Sales and Service

Correction of Description on the Linear Encoder Connection During the Linear Servo Motor Operation with the Mitsubishi General-Purpose AC Servo MR-J4-_A-RJ/MR-J4-_B-RJ Servo Amplifier

1. Correction Table

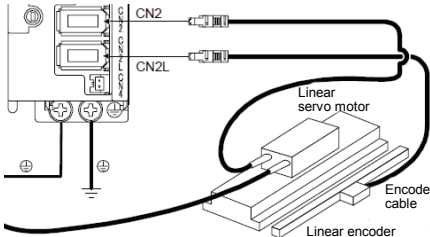
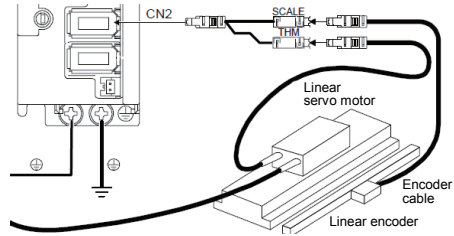
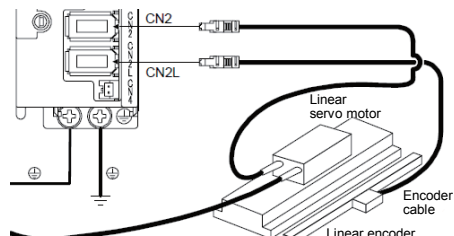
Thank you for your continued patronage of the Mitsubishi general-purpose AC servo and FA products. We inform you of the incorrect entries in the linear encoder connection diagram showing the linear servo motor operation with the MR-J4-_A-RJ/MR-J4-_B-RJ servo amplifier. Although incorrect connection of the linear encoder will not cause a malfunction, the linear encoder will not work properly. We apologize for any inconvenience, but please check the following before wiring.

The linear encoder connection diagrams in the catalog and each Instruction Manual will be corrected as follows.

Linear encoder	Incorrect	Correct
Two-wire/four-wire type serial communication		 <p>Connect the two-wire/four-wire type serial communication linear encoder to the CN2 connector. It can also be used for the standard MR-J4-_A/MR-J4-_B amplifiers.</p>
A/B/Z-phase differential	<p>Connect the two-wire/four-wire type serial communication or A/B/Z-phase differential communication linear encoder to the CN2L connector.</p>	 <p>Connect the A/B/Z-phase differential communication linear encoder to the CN2L connector.</p>
